UPDATE REPORT

READING BOROUGH COUNCIL ITEM NO. 12

PLANNING APPLICATIONS COMMITTEE: 3rd March 2021

Proposal: Demolition of detached house and annex and erection of 3 storey building for 3x3, 3x2, and 6x1 bed flats, with undercroft parking, landscaping

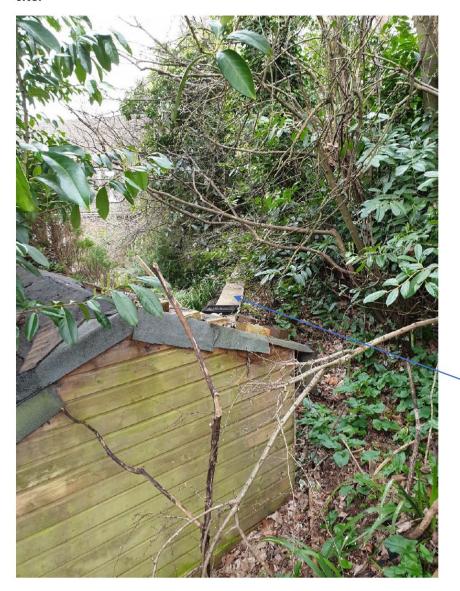
This picture has the laser level line from the front door threshold of 29 Westcote Road projected onto the rear of the summer house showing that it is ~0.5m below the 18/16 Parkside Road fence line.

The Colony drawing number '500 05-11 1:200 Westcote Road elevation' shows the ground level of the new development to be ~0.5m above the threshold of the front door of 29 Westcote Road.

Thus the proposed new site level is approximately at the same level as the top of the boundary fence between 18 and 16 Parkside Road.

This is also approximately in line with the top of the retaining wall seen in the picture below that runs right across the north of the 18 Parkside Road site.
